# Illinois Department of Transportation

## Memorandum

To: ALL BRIDGE DESIGNERS 04.3  
From: Ralph E. Anderson *Ralph E. Anderson*  
Subject: BRIDGE PARAPET JOINT DETAILS  
Date: August 2, 2004

## **Parapet Joint Detailing Policy Effective August 1, 2004**

Figure 3.2.4-1

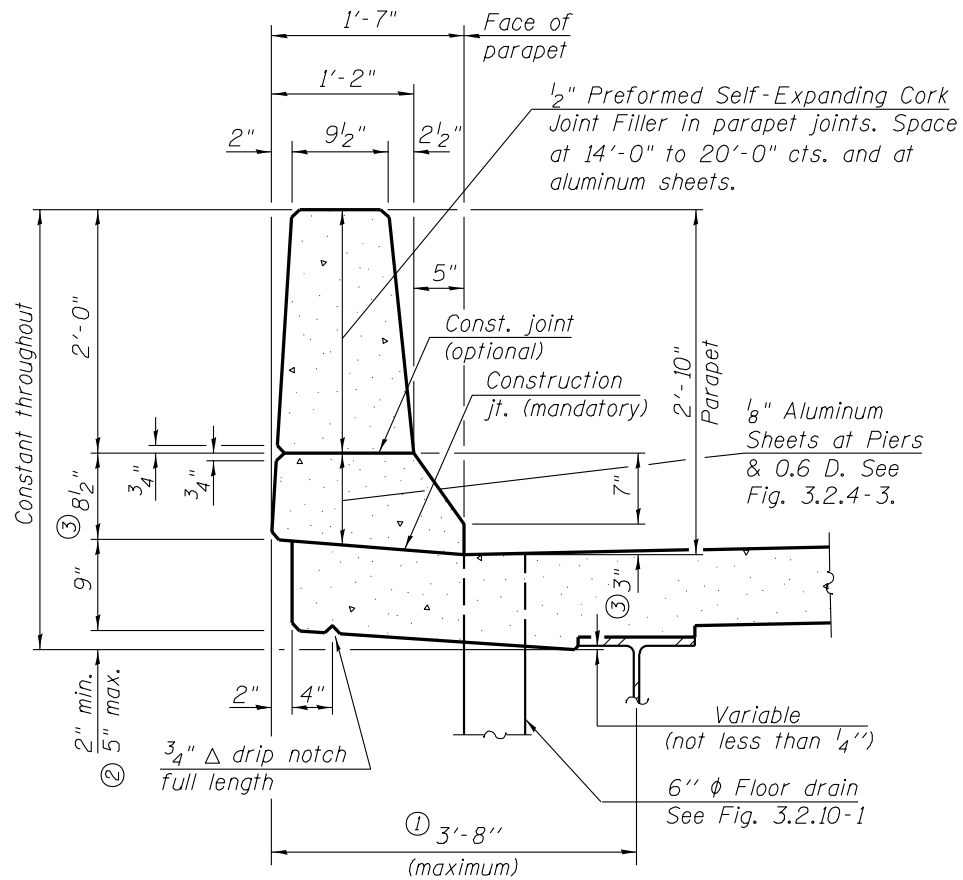
Joints shall be placed in the top portions of the parapets at 14'-0" to 20'-0" intervals. The joint shall be  $\frac{1}{2}$ " cork joint filler and sealed with caulk. The joints shall be placed as uniformly and symmetrically within a span as possible and no reinforcement, conduit, etc. shall pass through these joints.

See revised Bridge Manual Figures 3.2.4-1, 3.2.4-3, and 3.2.4-4.

Figure 3.2.4-3

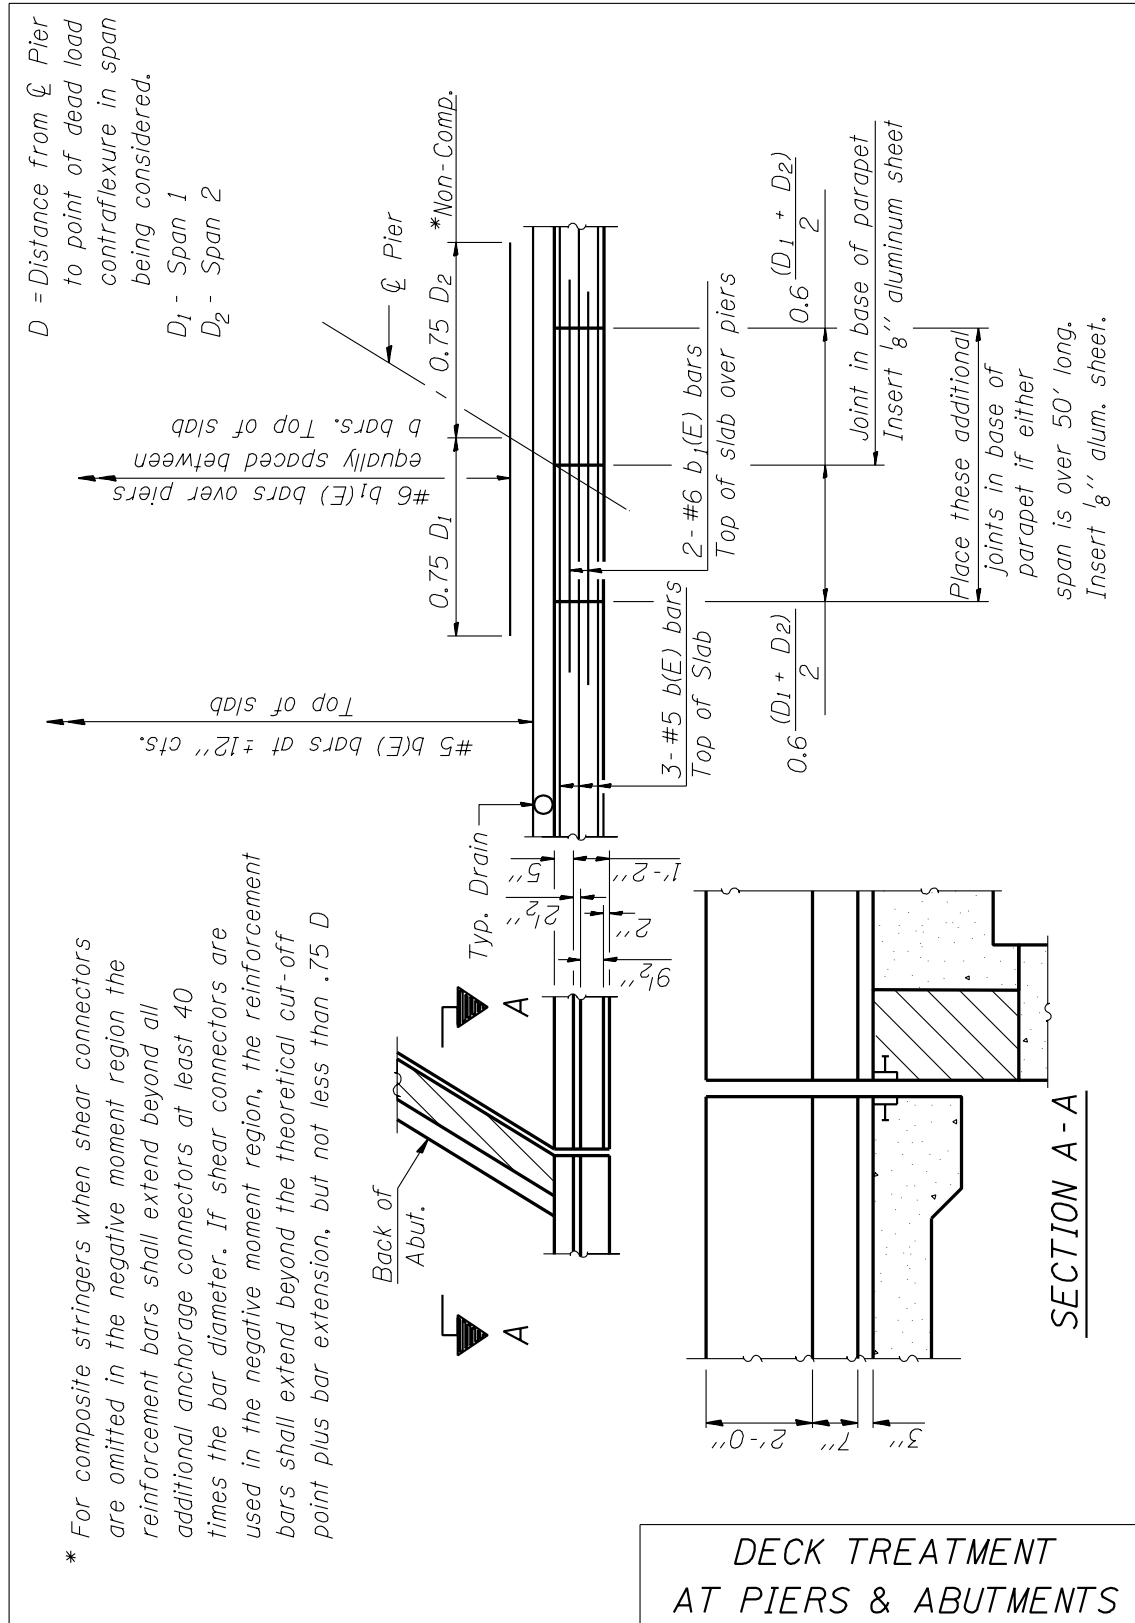
Joints locations shall be as shown in Figure 3.2.4-3 of the Bridge Manual and Figure 1.4.8 of the Prestressed Concrete Manual. These joints shall be full height. The joint in the base of the parapet shall be  $\frac{1}{8}$ " aluminum sheet. The joint in the upper portion of the parapet shall be  $\frac{1}{2}$ " cork joint filler and sealed with caulk.

Figure 1.4.8

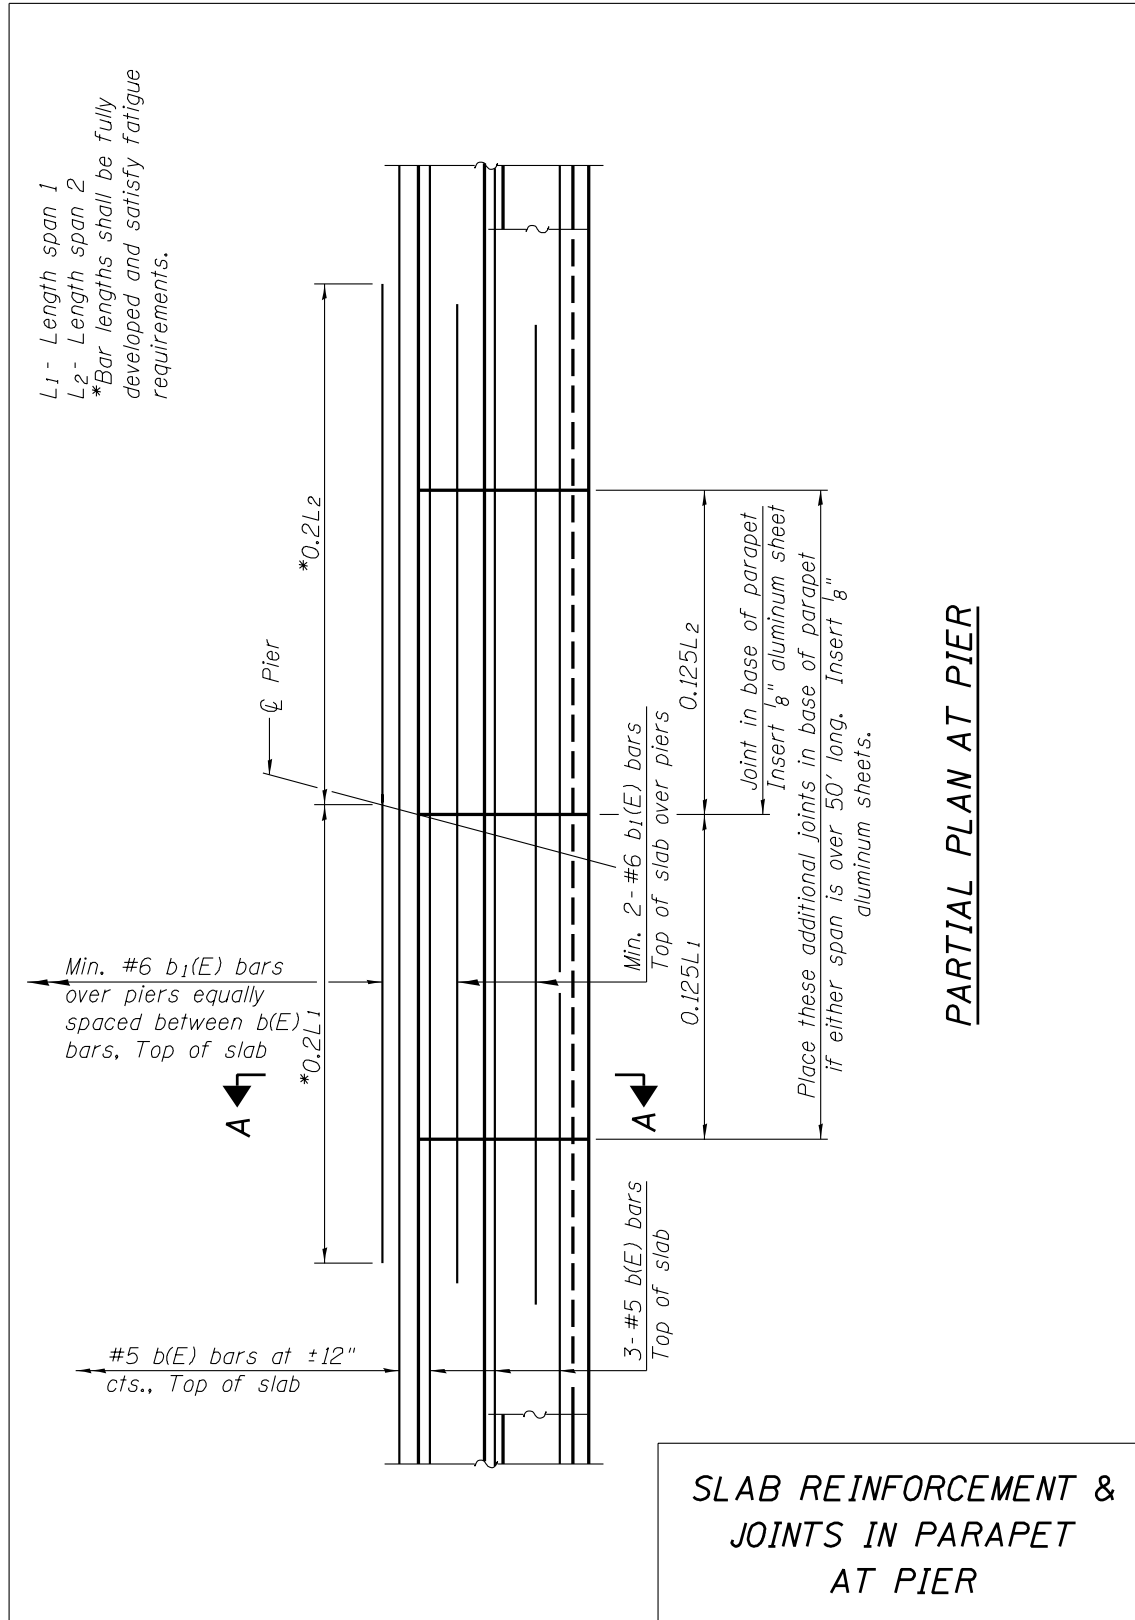
See revised Prestressed Concrete Manual Figure 1.4.8.

PARAPET JOINT  
DETAIL

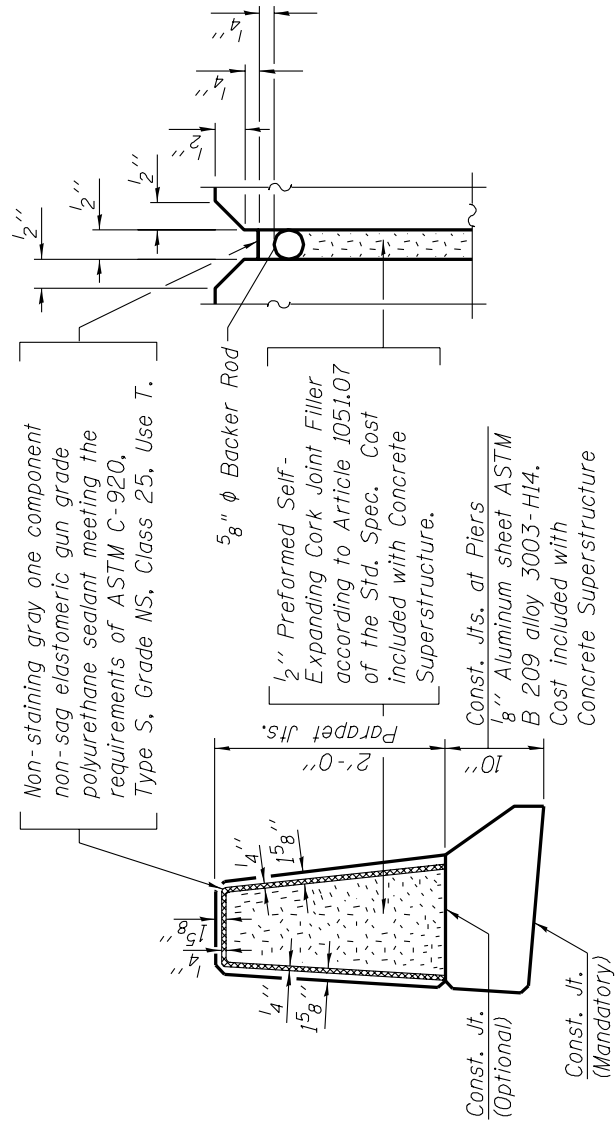
See new Parapet Joint Detail. This detail is available in the cell library detailib,cel with the name PARJNT. All affected base sheets have been revised to reflect this new policy. They are available for download from the IDOT website.
